Sheringham Shoal and Dudgeon Offshore Wind Farm Extension Projects

Outline Operational Drainage Strategy (Revision B) (Tracked Change Version)

March 2023
Document Reference: 9.20.1
APFP Regulation: 5(2)(q)

Onshore Substation Drainage Solution - Hydraulic Verification Calculations

Project:	SHERINGHAM SHOAL & DUDGEON WINDFARM ONSHORE CABLE FEED	
Revision:	F03	Dwg Title: SUBSTATION OUTLINE DRAINAGE STRATEGY INFILTRATION METHOD
Scale:	1:2000	Dwg No: C282-MU-Z-XD-00118-01
Sheets:	1 OF 1	Purpose of Issue: FOR INFORMATION
Internal Proj Ref:	1002-000591	Client Ref Number: -

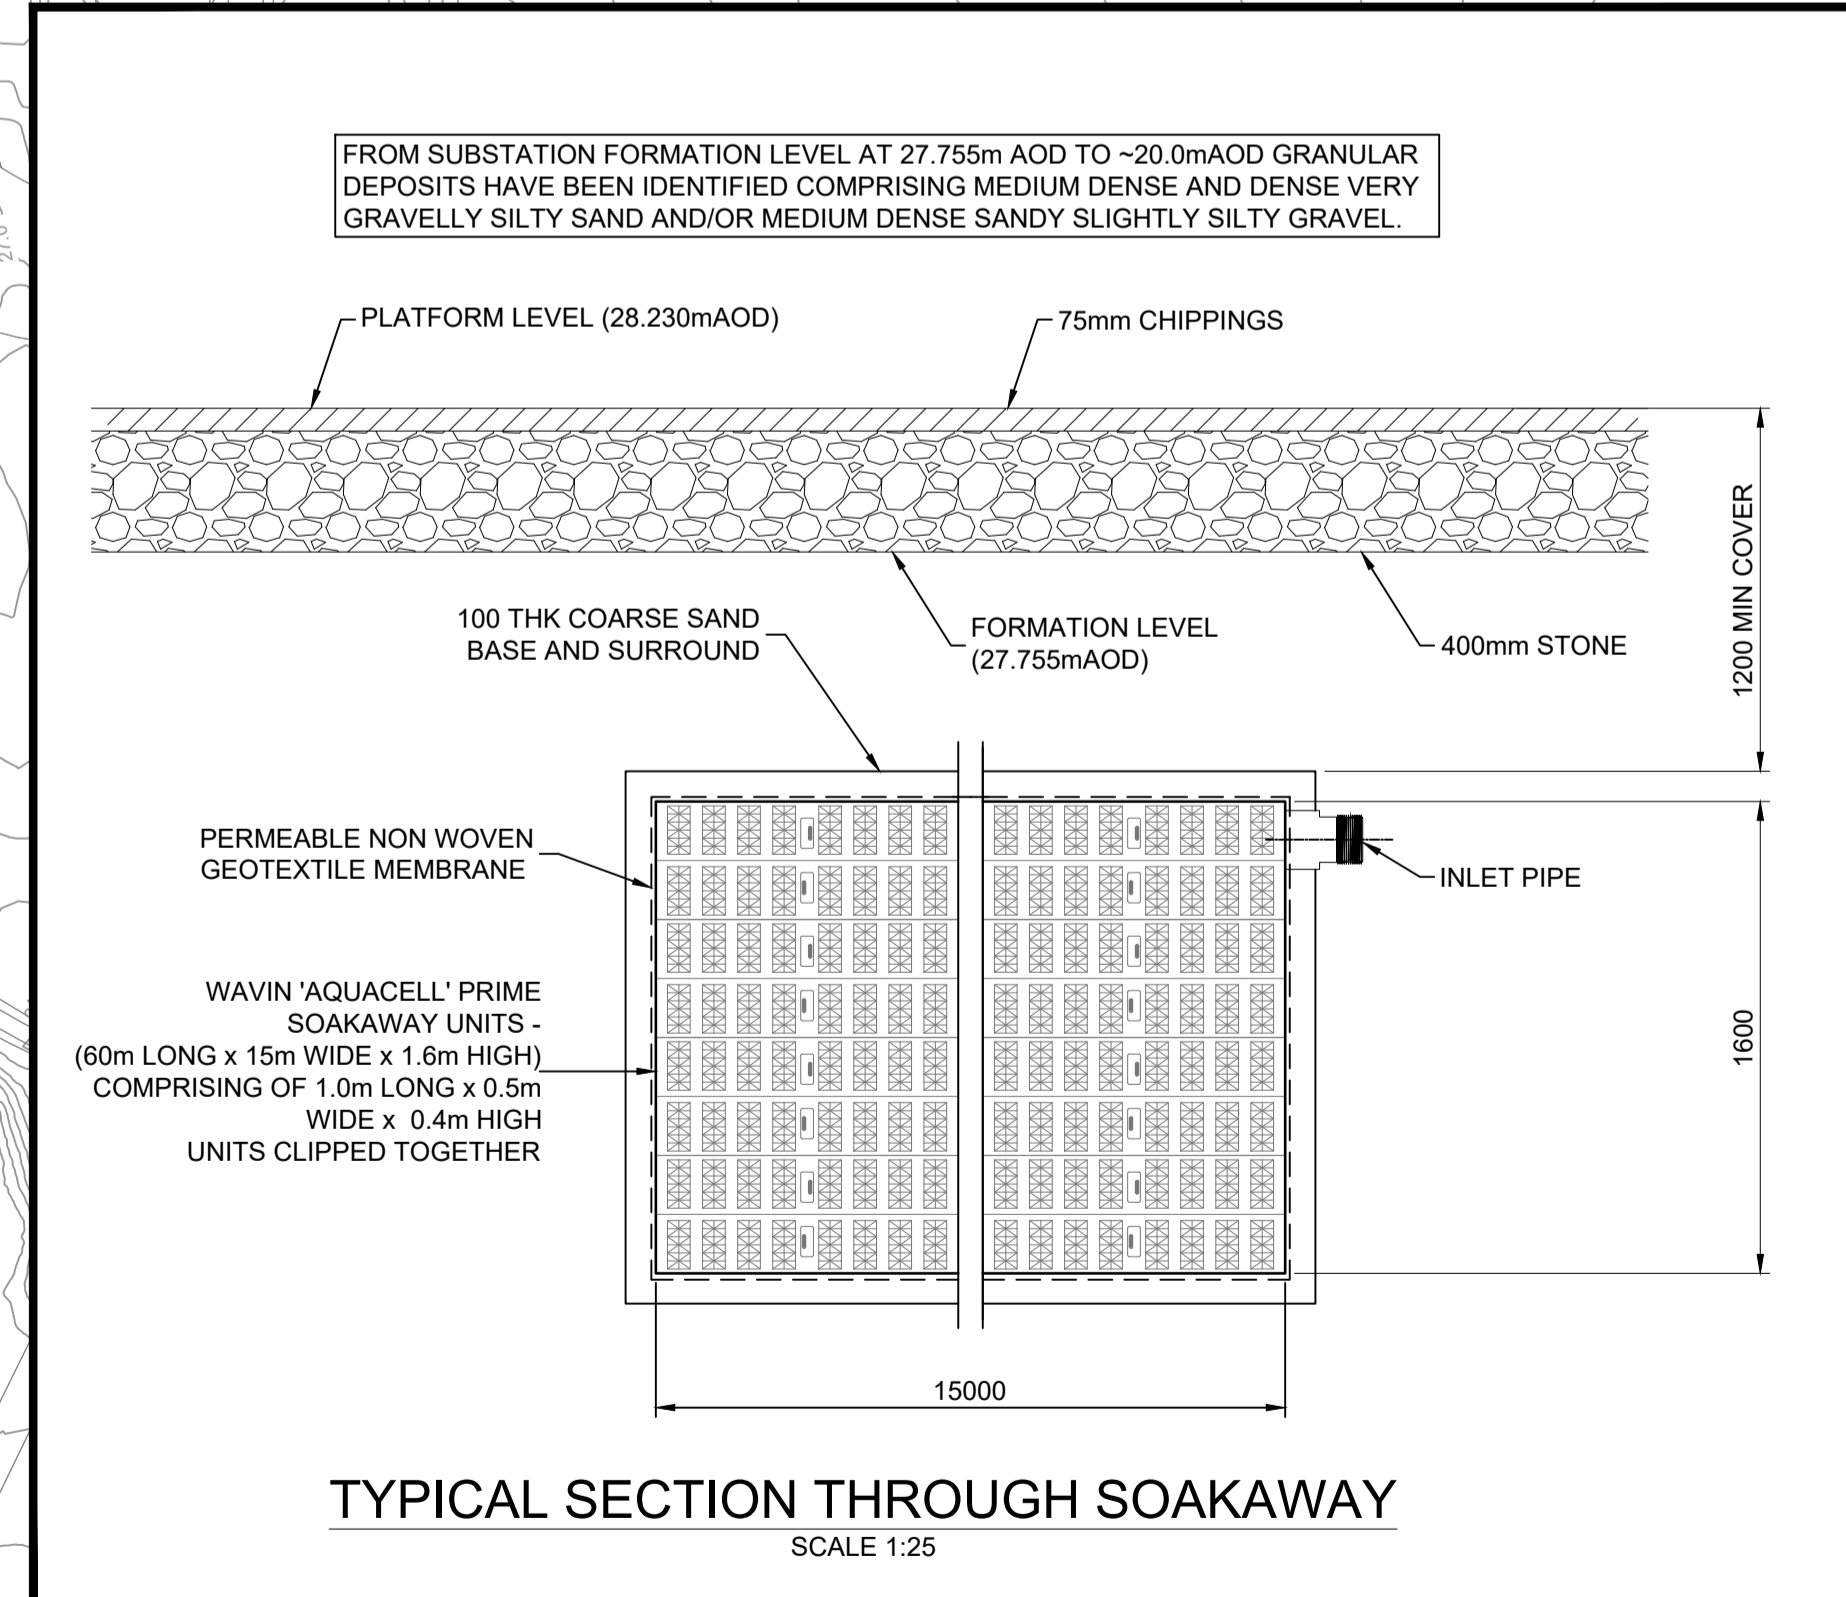
25. [Option 1 is in accordance with BRE 365 and NCC LLFA Statutory Consultee for Planning Guidance Document, Version 6.1. The results from this option are in general agreement with the Tekla® Tedds output with slight differences in the rainfall parameters. An additional total storage volume of 320m³ above the total volume indicated by Tekla® Tedds is indicated to be required. This larger volume has been included in the design and is shown on drawing C282-MU-Z-XD-00118-01_F03.](#)

REV	DRAWN	CHK	APP.	DATE	REVISION COMMENTS
F03	S.LYONS	M.PERKINS	J.CURRAN	28/02/23	SOAKAWAY AREA INCREASED IN LINE WITH MICRODRAINAGE VALIDATION
F02	L.EDGE	M.PERKINS	J.CURRAN	27/07/22	SOAKAWAY DETAILS ADDED
F01	S.LYONS	M.PERKINS	J.CURRAN	01/07/22	ISSUED FOR INFORMATION

WAVIN AQUACEL PLUS OR SIMILAR GEOCELLULAR SOAKAWAY UNITS. AREA = 900m². REQUIRED STORAGE VOLUME = 1,425.5m³. TOTAL STORAGE VOLUME = 1,440m³. AQUACELL TO HAVE 1.2m MINIMUM COVER AND TO BE 1.6m DEEP. MAXIMUM VERTICAL LOAD = 70t/m²
